To: Development Permit Panel
From: Joe Erceg
Manager, Development Applications
Date: June 3, 2003
File: DP 02-221259
Re: **Application by Ah Ten Holdings Ltd. for a Development Permit at
6300 Birch Street, 9760 Ferndale Road and 9771 Alberta Road**

Staff Report

L-4

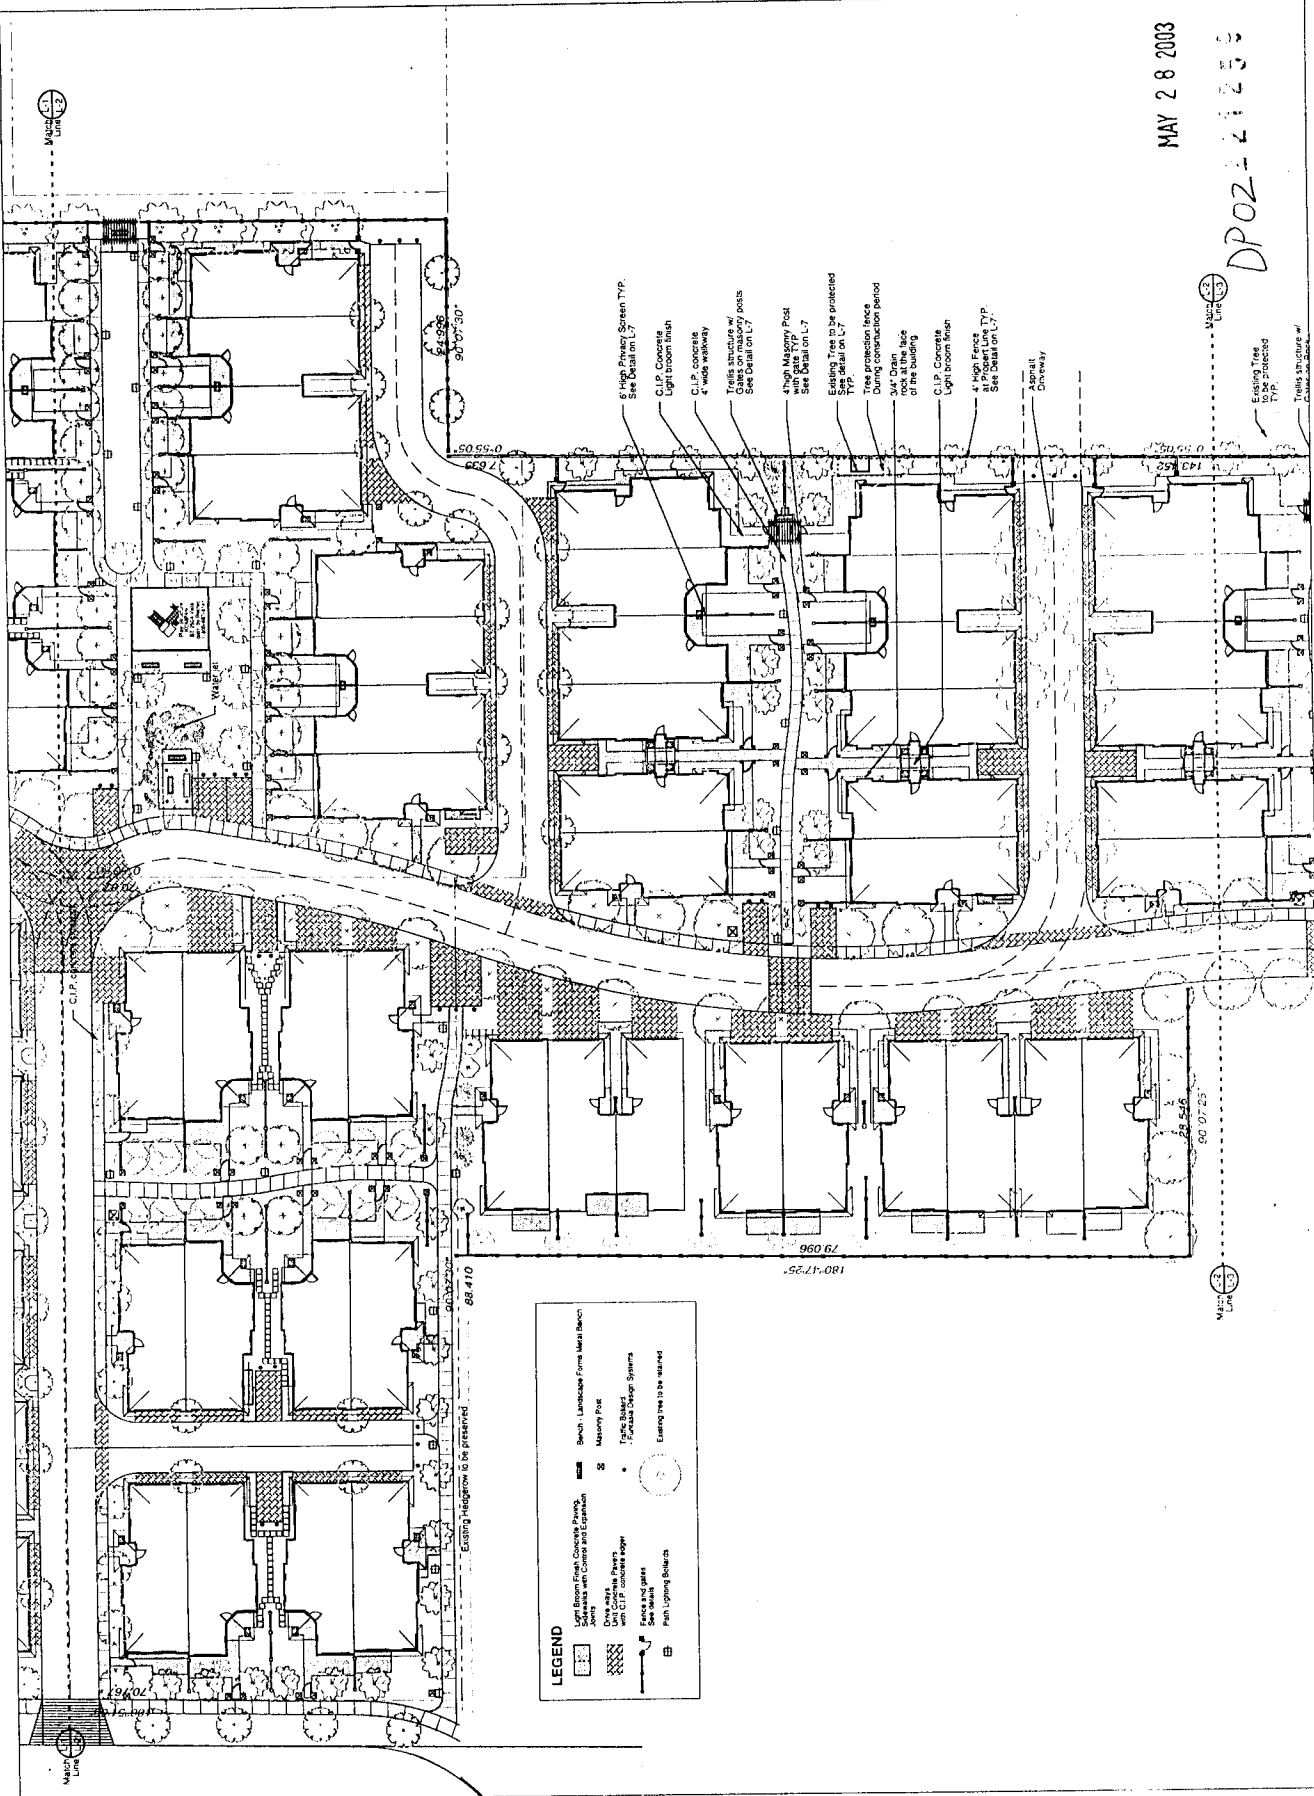
1. Existing healthy trees should be plotted on the landscape plan or site plan, so that it is clear whether they are being retained or not. The ones we especially feel should be retained are a large Willow (*Salix babylonica*) near the City park, a Cedar toward the north-east corner of the site, and a Pine (0.35m) near the east property line. Trees to be retained should be fenced before site work begins. The north-south road may split and go on either side of the Willow, provided it is outside of the drip line (see sketch attached). If the road is within the drip line, we require an arbourist or landscape architect's report as to measures to be taken to protect the roots. Before a Building Permit is issued, we require evidence that a professional will be monitoring existing trees during construction, and that a tree-management plan has been prepared. We note that it is an offence under the *BC Wildlife Act* to cut trees containing active bird nests during the nesting season (starting in March). You may want to have a biologist visit the site and advise on this. ***The existing trees to be retained have all been fenced. The arborist classified some trees along the Ferndale frontage as "not suitable for retention", and they were removed. The applicants commissioned a study by a Biologist who monitored the site for active songbird nests protected during the nesting season pursuant to the BC Wildlife Act and the Canadian Migratory Bird Act. No active nests were found, and subsequently all of the Birches and other trees not suitable for retention were removed. The site is currently being pre-loaded with sand.***

NOTE: Proximity of the existing willow tree to the building and the characteristics of the species together with the existing growing conditions of this tree may prove this tree unretainable.

New trees size summary :

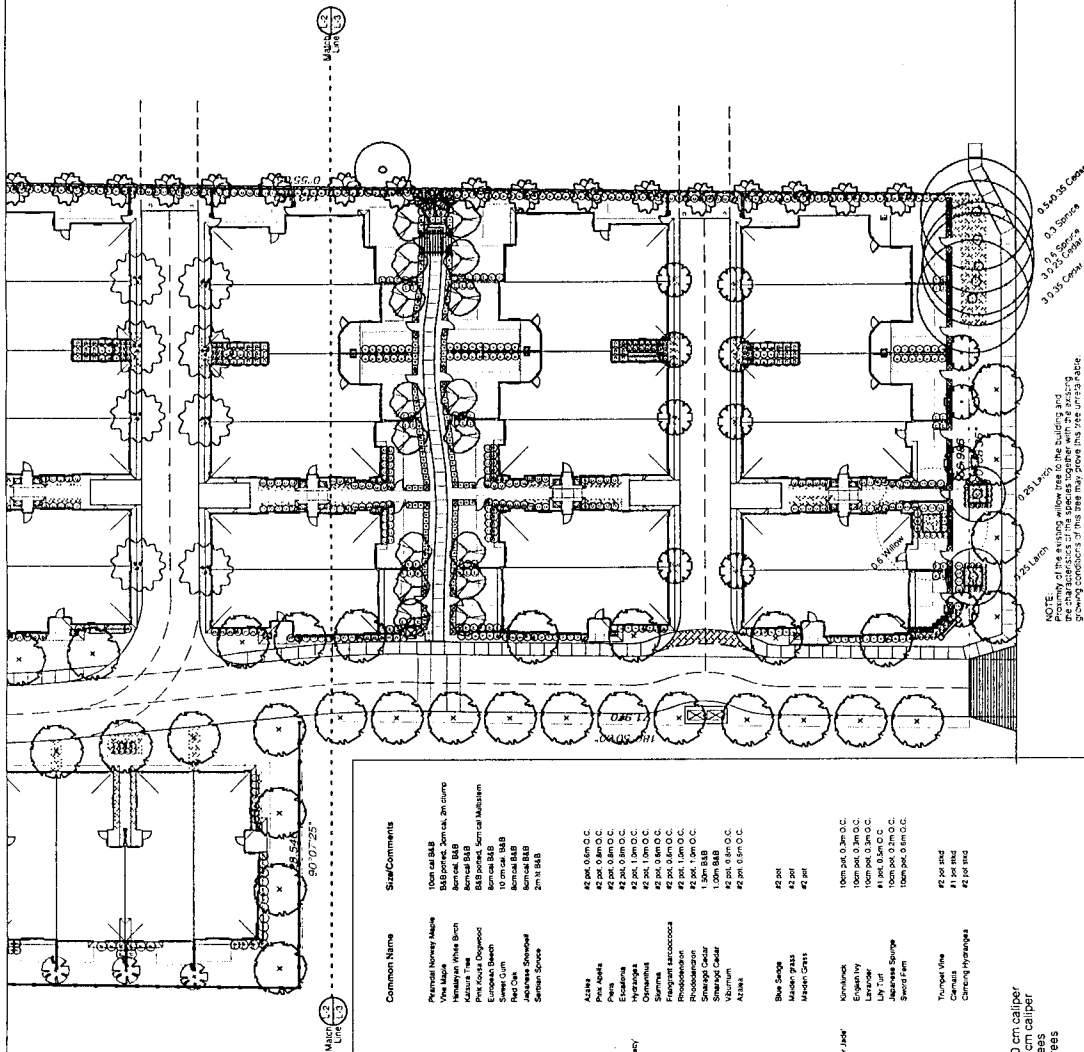
2. Replacement trees should be shown on the landscape plans. We note that the previous Development Permit indicated 160 replacement trees at 4 in. calliper, and 170 at 3 in. calliper. Since that date, City policy has changed, and the *Official Community Plan (OCP)* General Guidelines for Landscaping indicate that: "for every existing major tree which is removed, two trees of minimum 15 cm (5.5 in.) calliper are to be replanted as replacement trees." ***The tree survey prepared by the applicants indicated about 12 mature "trees worthy of retention" and 22 "not worthy of retention". Nine trees are being retained. There was also a forest of generally smaller Birches. In addition to other landscaping, the applicants are planting 117 four-inch (10 cm) calliper trees and 197 three-inch (8 cm) trees as replacements for existing trees lost due to construction.***

117 trees with 10 cm caliper
197 trees with 8 cm caliper
52 multistem trees
10 evergreen trees

The total number of new trees on site is 378, providing a 1 for 1 replacement. Of the 340 trees, a total of 12 trees were noted suitable for retention, 2 of which "add to the removed due to maintenance with construction and pruning. A total of 10 trees are being retained.
